# Thurrock Power Ltd Comments on Historic England's Deadline 2 Submission

## **Deadline 3**

#### 1 THURROCK POWER LTD COMMENTS

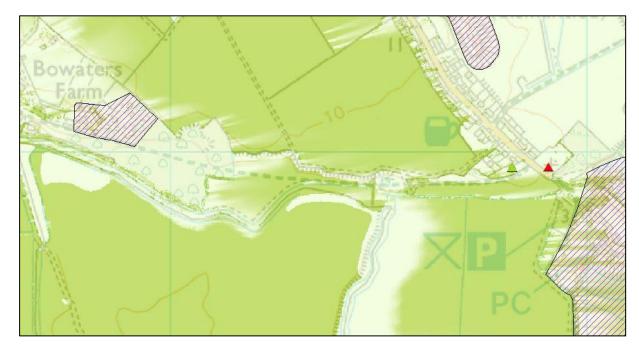
- 1.2.1 On page 12 of the representation Historic England (HE) has commented that Figure 2.6:
  Landscape and Visual Impact Assessment ZTV and 10 km Study Area (Chapter 6: Landscape and Visual Resources of the May 2020 ES) shows that the Grade I listed Church of St Katherine is within the zone of theoretical visibility, therefore this church and the nearby Grade II listed Old Rectory should not have been scoped out of the initial assessment.

- 1.2.2 The applicant can confirm that the Grade I listed Church of St Katherine is <u>not</u> within the zone of theoretical visibility (ZTV) for the proposed development. The image below shows the relevant part of the ZTV, with the Grade I listed Church of St Katherine shown as a red triangle and the Grade II listed Old Rectory as a green triangle. The areas shaded in green in the image are those from which some or all of the proposed development would be visible. This lack of intervisibility, along with the observation that the proposed flexible generation plant development site does not make a meaningful contribution to the setting of either of the two listed buildings, justifies their exclusion from the initial assessment.
